**Rezoning Application:** PD 25-0587

**Zoning Hearing Master Date:** July 21, 2025

**Development Services Department**

This is a request to rezone a site from Planned Development (PD) 14-0314 and PD 90-0052 (as most recently modified by MM 09-0371) to a new Planned Development (PD) in order to add a parcel for a parking garage, revise the permitted uses, and increase the max floor area ratio from 0.56 to 0.63.

#### 8.0 PROPOSED SITE PLAN (FULL)

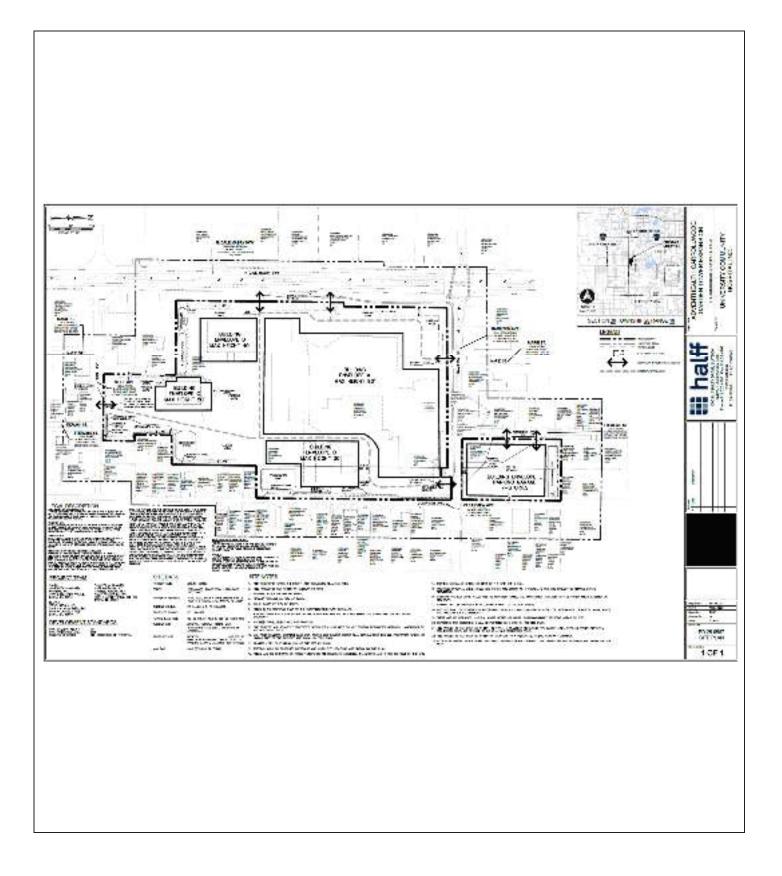
- 1. Depict buffer and screening along the eastern boundary adjacent to residential zoning on the Building Envelope E parcel.
- 2. Add graphic to site plan depicting an example of architectural standards for the parking garage.

- e. Building envelope E maximum building height 7-stories, 83 feet. The parking garage façade shall feature architectural elements, generally consistent with the graphic provided on the certified site plan.
